Docket Item #14 & 15  
BAR CASE # 2010-0183 & 0184

BAR Meeting  
July 21, 2010

**ISSUE:** Permit to Demolish and  
Certificate of Appropriateness for Alterations

**LOCATION:** 1012/1014 King Street

Figure 1: 1964 Historic Photo

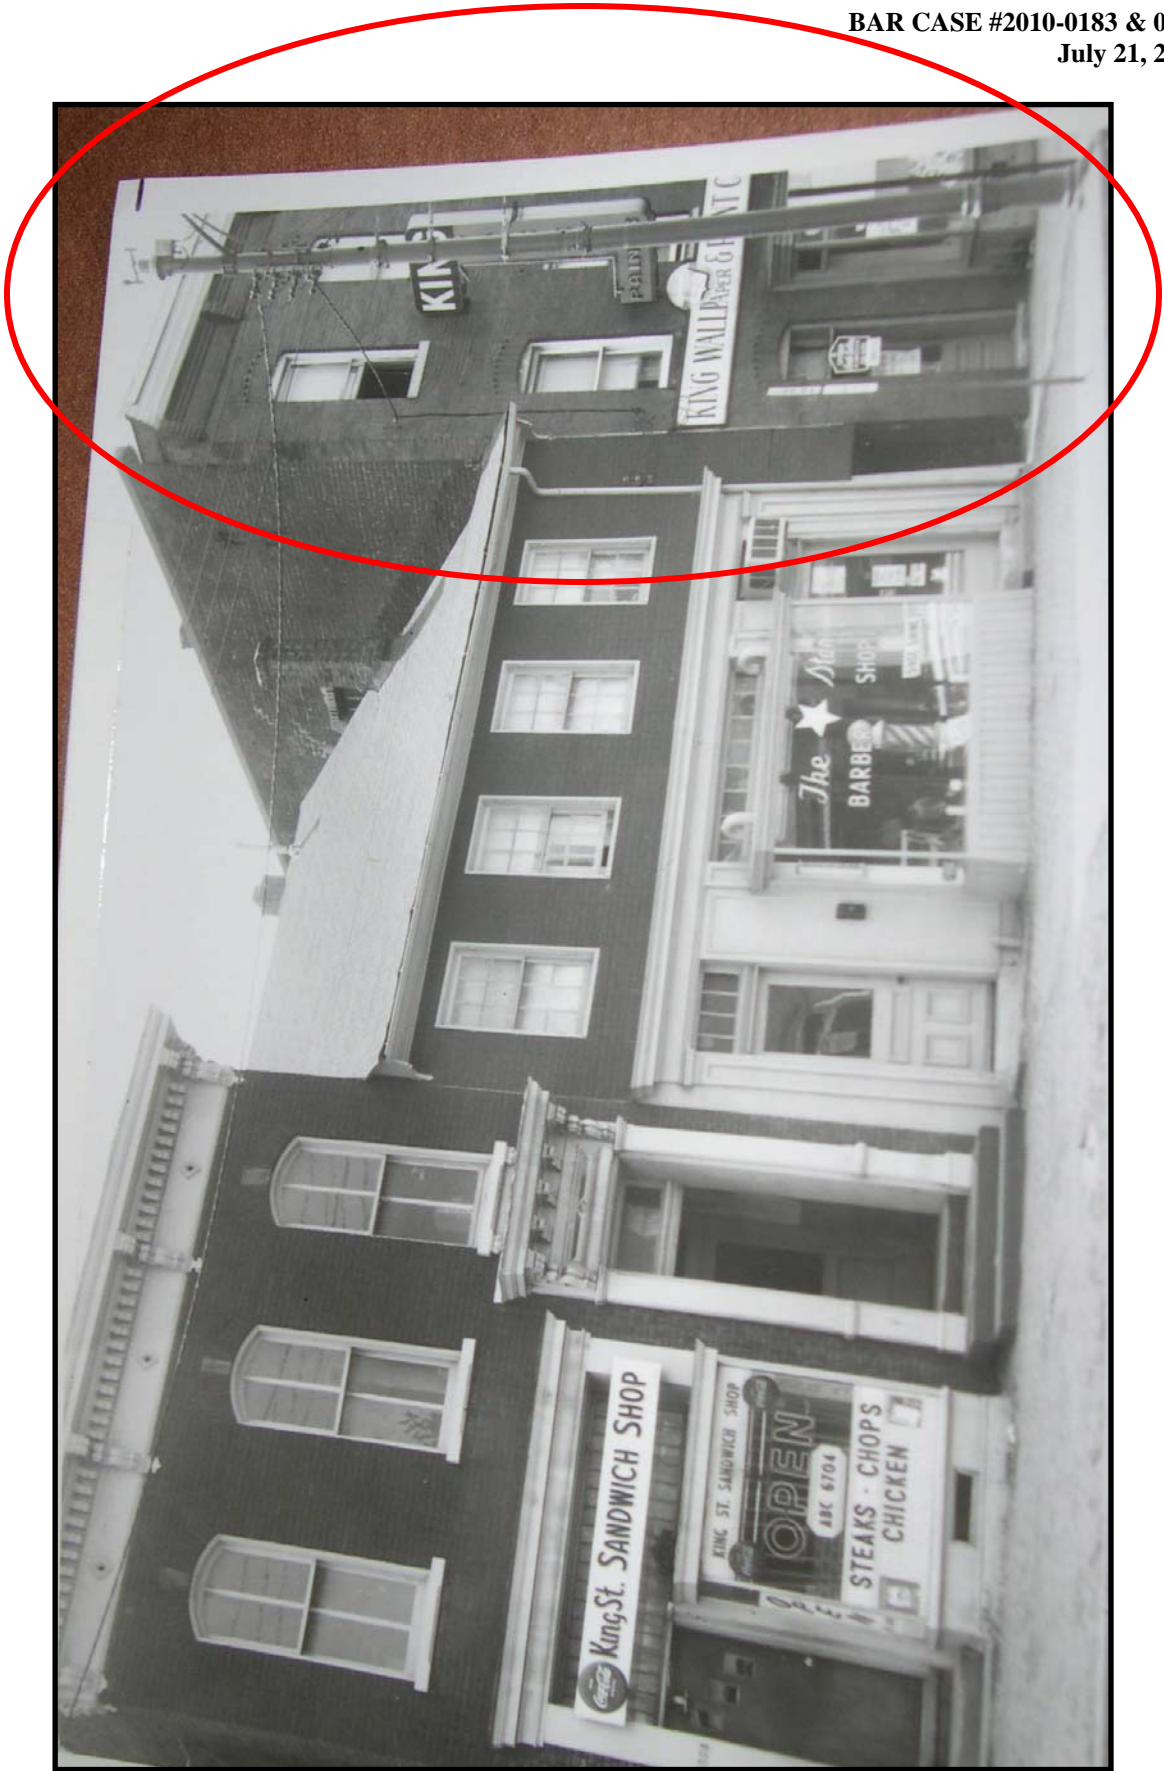
During the Staff’s review of the proposal, a 1964 photo of a portion the subject building’s front façade was uncovered. In this photo some of the original first floor storefront details can be extracted. These include a decorated segmental brick arch above the entry door (matching the existing windows above), a half-glazed two paneled wood door with a single light transom, a wood signboard above the storefront, and a Colonial Revival projecting storefront detailed with a carved cornice and wood paneled base. This design is typical for a late 19<sup>th</sup>/early 20<sup>th</sup> century storefront.<sup>1</sup>

A basic tenant of restoration philosophy when faced with a missing historic feature is that it should be reconstructed based on historical, pictorial or physical documentation. It is only when there is no evidence or documentation that a new design should be created that is compatible with the historic character of the building. In light of the photo documentation of the historic storefront, Staff believes that the original segmental arches above both doorways may still be concealed behind the existing sign band and encourages their preservation. If they do not exist, Staff recommends that segmental arches be recreated to match the photograph and the windows above to the maximum extent possible. Staff also recommends replication of the original wood, half-glazed doors with two horizontal lower panels capped with a single light transom.

Staff would support restoration of the projecting bay window to match the photo but also supports a storefront picture window similar to the one proposed by the applicant. However, where the windows above are one-over-one sash, it is unlikely that door or storefront window transoms would be multi-light. Staff therefore recommends that all transoms be single light. Finally, Staff believes that the bulkhead below the new picture window should be fabricated on site out of milled and joined, wood composite solid material to more closely reflect the historic bay window design.

1. That the signage to be applied on the signboard be reviewed by the BAR, or administratively approved by staff, prior to installation.
2. That the proposed precast lintels above both of the entry doors are replaced with the existing restored decorated brick segmental arches, or if these no longer exist, with new segmental arches to match those on the windows above.
3. That the proposed full-light wood doors with four-light transoms are replaced with wood, half-glazed doors with two horizontal lower panels capped with a wood, single light transom.
4. That the proposed picture window with nine-light transom and slate base be replaced with a single light picture window with a single light transom with a painted paneled base which is fabricated on site out of milled and joined, wood composite solid material.

Figure 5: Proposed Front Elevation

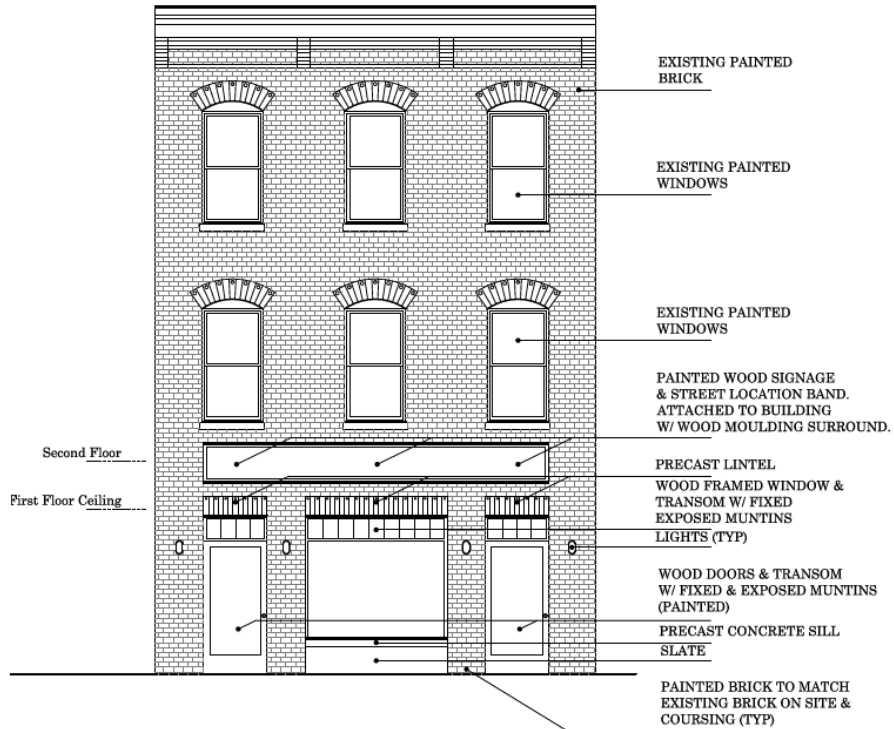
The existing wood storefront on King Street will be removed and replaced with new doors and a picture window with simulated divided light transoms capped with precast lintels formed into decorative “soldier arches”.

Figure 7: Proposed Rear Elevation

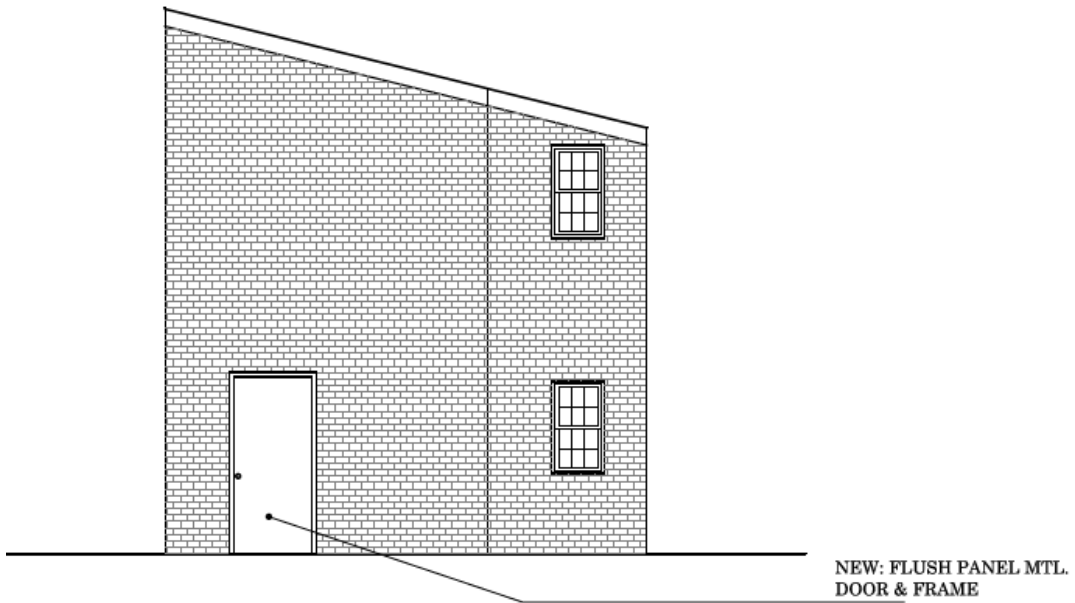
In the opinion of Staff, none of the above criteria are met. The existing wood storefront and picture window were installed in the 1965 renovation and, therefore, do not contribute to the integrity of this Victorian resource. The proposed demolition of 23 square feet on the rear elevation for the installation of a new metal door is located on the rear of the two-story historic ell, and only visible from the public service alley. The subject flush metal door is very minimal in scale and utilitarian in design. Additionally, the Sanborn Fire Insurance Maps from 1896-1940s convey that over the years one-story extensions have been added and removed from the rear elevation of this addition. Staff recommends approval of the Permit to Demolish application.
